Application No: 3926/22

Applicant: Dublin City Council Housing and Community Services Department

Location: Site c. 1.77 ha at Shangan Road, Ballymun, Dublin 9

Proposal: Construction of 93 residential dwellings which will consist of the following:

1 Proposed Site Plan
Scale: 1:500

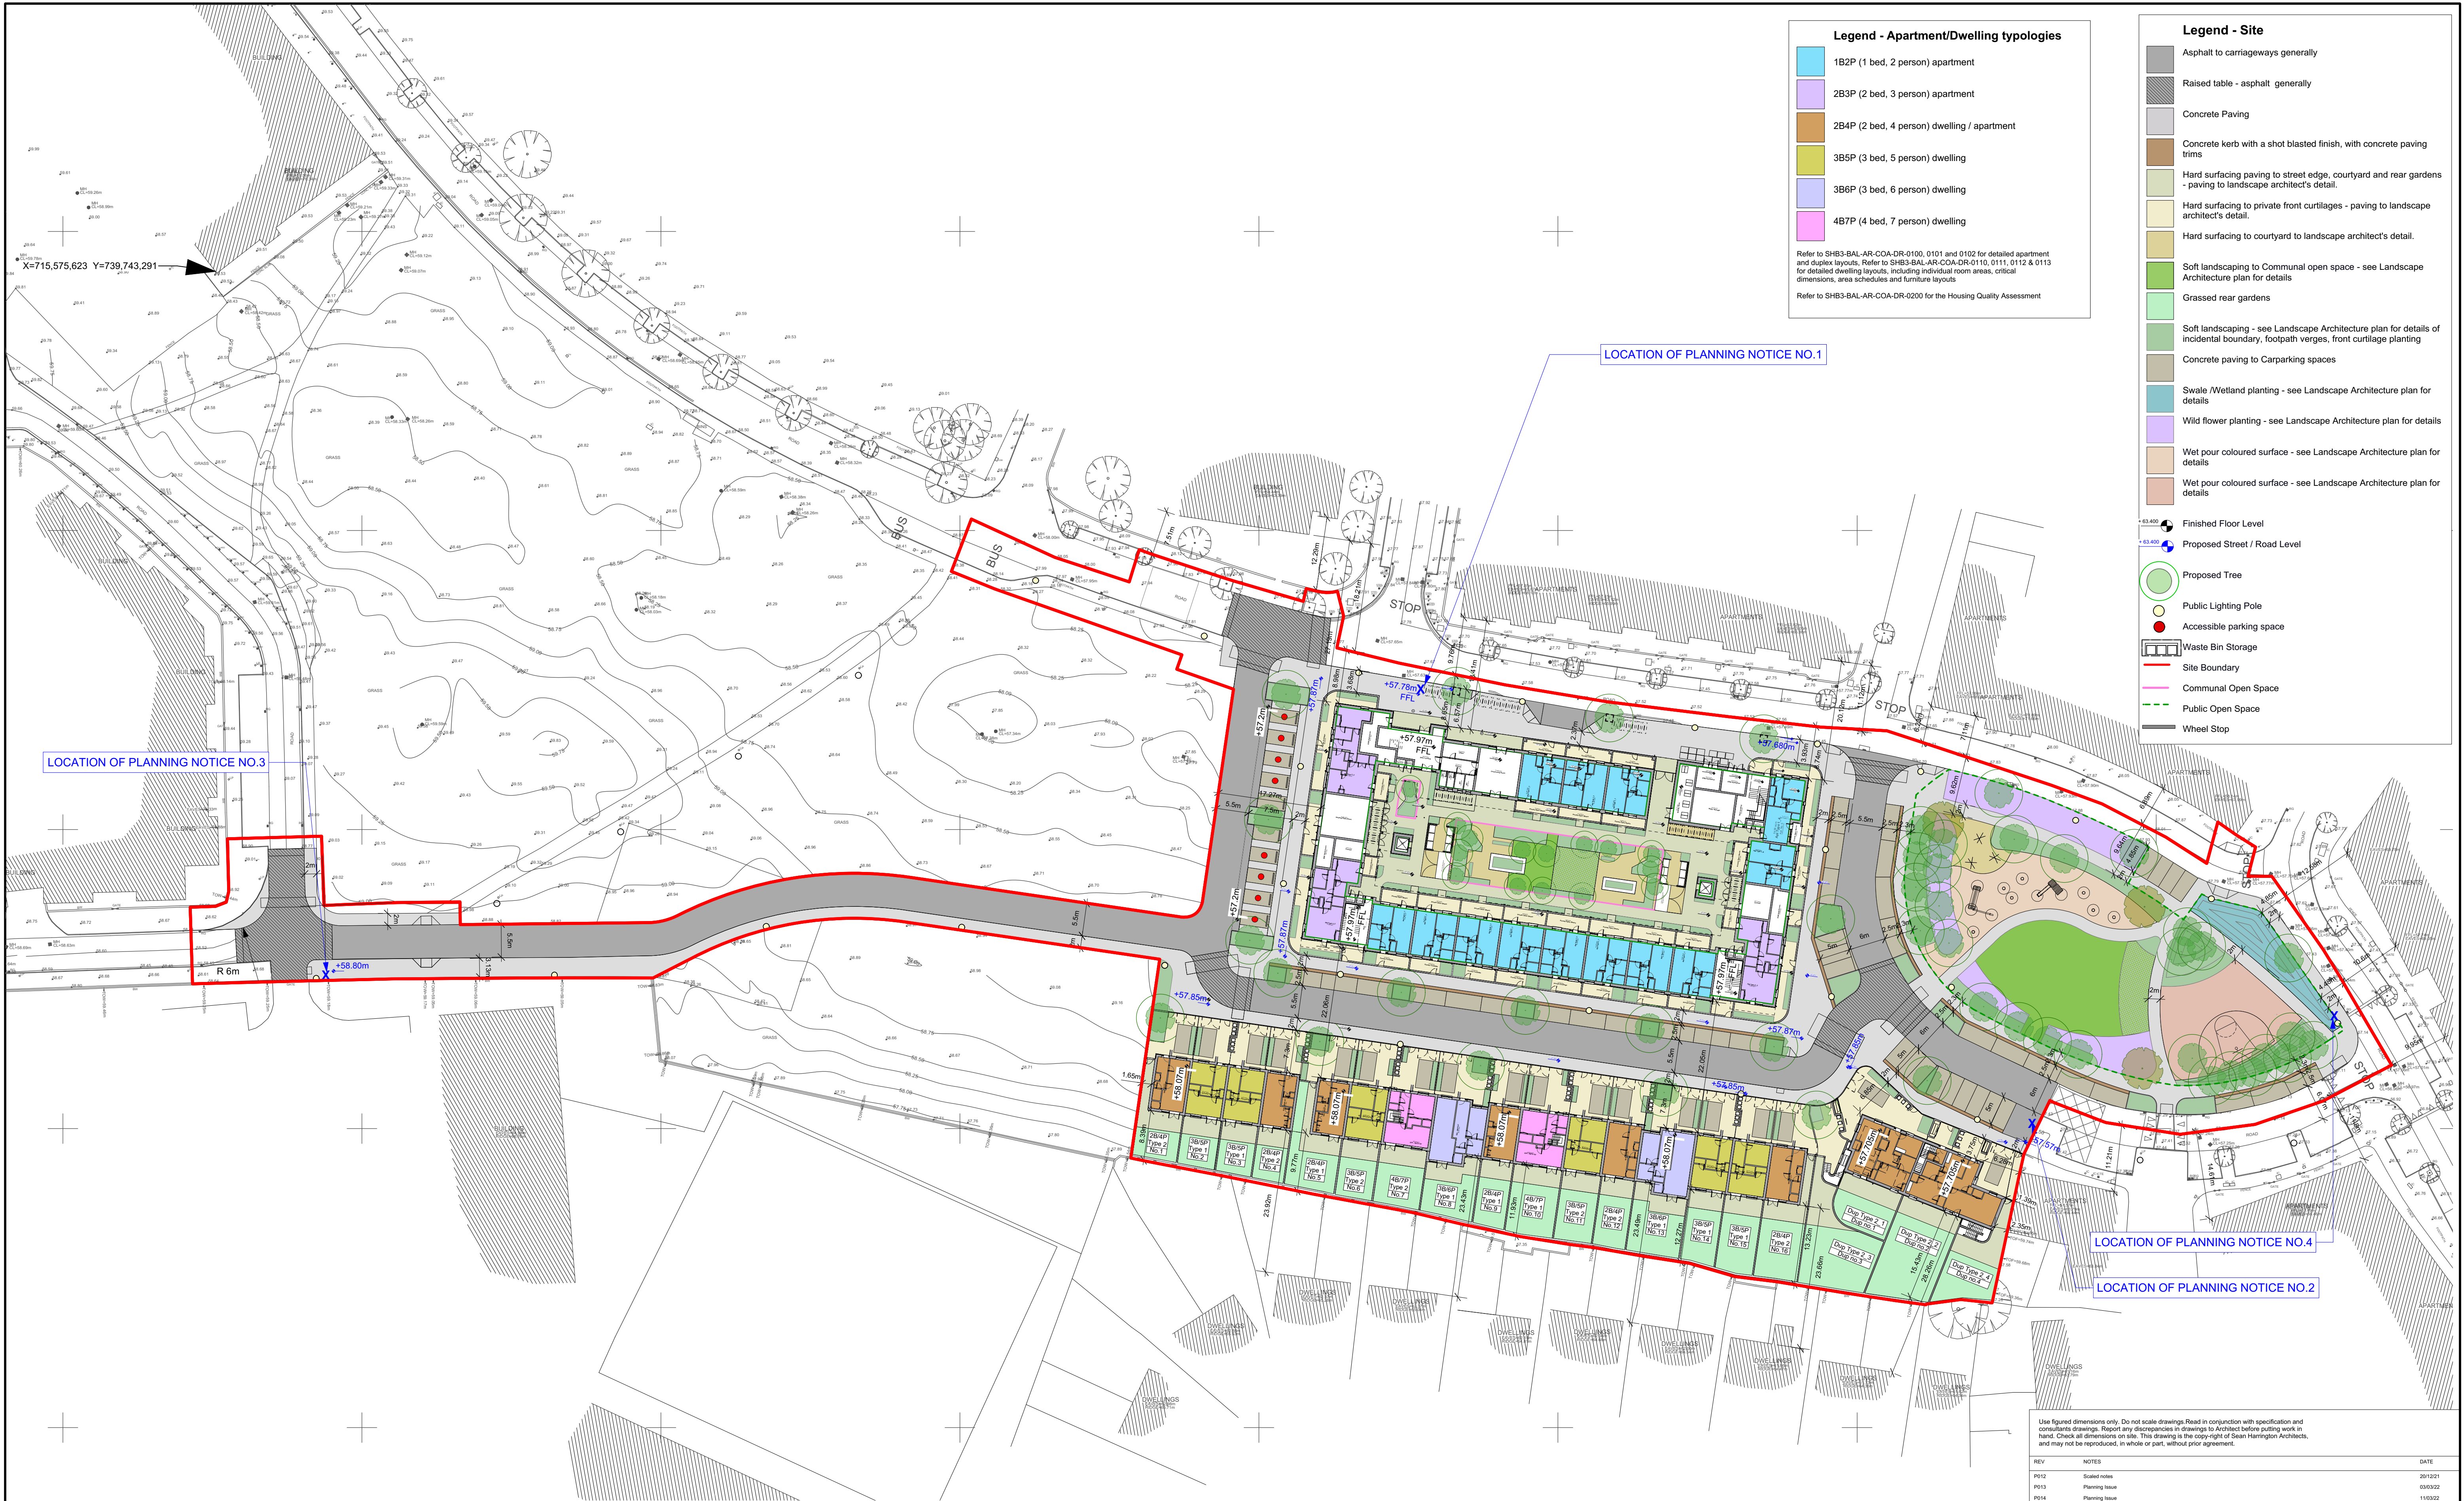
- Some concern from residents in Oldtown re overlooking and overshadowing

It is considered that the most sensitive properties in relation to any potential overlooking would be the established two-storey houses on Oldtown Avenue, located immediately to the south of the site, where the rear gardens of same back onto this application site. It is noted that minimum 22 metre separation distances are proposed between the rear elevations of the new two-storey dwellings and the elevations of the proposed duplex units and the rear of the existing two-storey dwellings along Oldtown Avenue i.e. nos. 43 – 73a (odd only). The dwellings proposed are two-storey. The separation distances are adequate and comply with development plan requirements to ensure privacy levels are not unduly impacted upon. As the proposed development is located to the north of these established dwellings. The closest dwellings, two-storey in nature, will not lead to overshadowing of existing rear gardens on Oldtown Avenue.

Site 10 is at a higher level to the rear gardens of Oldtown Avenue however it is proposed to install a 2.0m high post a panel fence on the high side to eliminate potential overlooking. Discussion will take place with residents closer to construction to resolve any possible boundary concerns.
